**CITY OF ALLENTOWN
HISTORIC ARCHITECTURAL REVIEW BOARD
FINAL REVIEW SHEET
February 5, 2018**

Case # HDC-2018-00003 Proposal to maintain the front door hardware and trim on façade.

Property located at: 204 N. 8th St.

Case # HDC-2018-00003

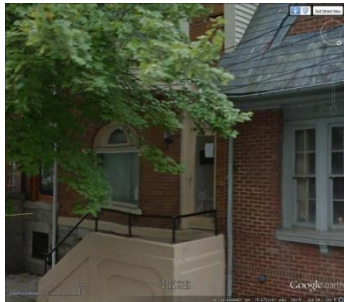
Evaluation, effect on historic district, recommendations: The entry door lock set is not historically appropriate; it replaced a metal door knob. Historically, the hardware would have had a separate deadbolt lock above a knob. The need for ADA compliant hardware is understandable since this is now a multi-unit property; however keyless systems are not required or necessary and are not appropriate in style for the historic district. Ideally, the lockset should be a deadbolt above a lever, either with a single back plate, or separate. If a keyless deadbolt is a necessity, then a historically appropriate design should be utilized as described in above submission.

Discussion: The discussion on the keyless entry hardware for 329 N 9th St also covered the same hardware at 204 N. 8th St. The existing hardware will be replaced with new similar hardware in dark bronze color.

1. The proposal to maintain the front door hardware and trim on facade at 204 N 8th Street was presented by Kenneth Barreto.
2. The lock will be replaced with a dark bronze color keyless entry lock matching 329 N. 9th St. The new lock must have staff approval.
